From: Waters, David [David.Waters@pgnmail.com]
Sent: Monday, July 16, 2012 3:33 PM
To: Habib, Donald
Cc: Rose, Dana; Kitchen, Robert; Wilkins, Tillie
Subject: Draft Change Pages for Levy COLA R5 - Message 1
Attachments: Changed Pages from LNP_FSAR_CHAP13_Rev5Draft.pdf; Part 11 QAPD DRAFT.pdf

Attached are draft revisions to the Part 11 QAPD and changed pages from Part 2 FSAR Chapter 13 for the Levy COLA that address organization changes based on the Progress Energy-Duke Energy merger, as requested. These changes are planned to be submitted as part of LNP COLA R5.

**Levy Nuclear Plant Units 1 and 2
COL Application
Part 2, Final Safety Analysis Report**

**CHAPTER 13
CONDUCT OF OPERATIONS**

Figure II.1-1

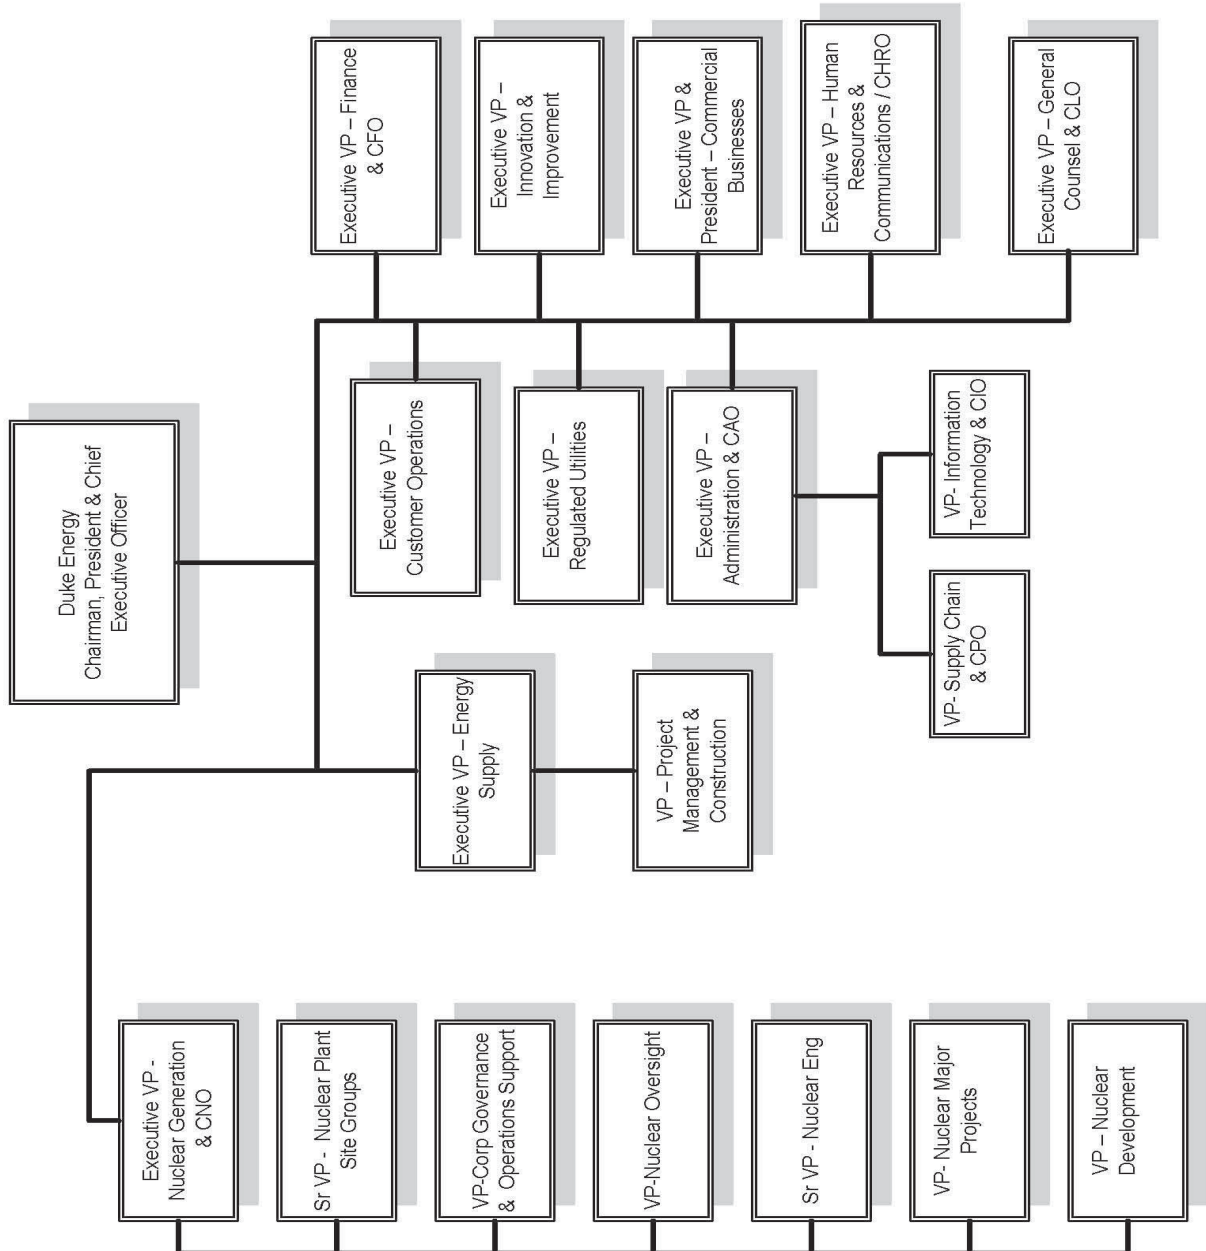
- Part II, Section 1.5 – 1.10 – Changed section numbering to reflect changes in section. No changes in section descriptions.
- Part II, Figures II.1-1, II.1-2, and II.1-3 – Revised figure to reflect new organizational structure and titles.
